INFORMATION BULLETIN

Bulletin No: JC-012-08

Honda Engines Gas Cap Bulletin

GX120 • GX160 • GX200 FUEL FILLER CAP DOES NOT VENT PROPERLY

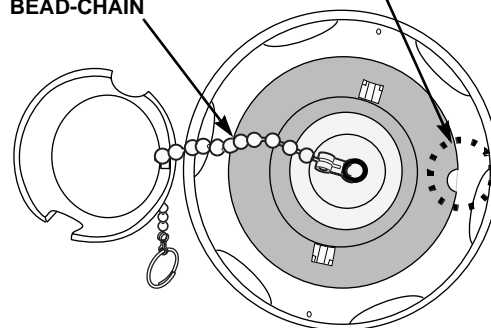
Replace the fuel filler cap with a new style cap. The new style cap can be identified by a notch in the gasket, as shown.

The new style cap has a notch in the gasket.
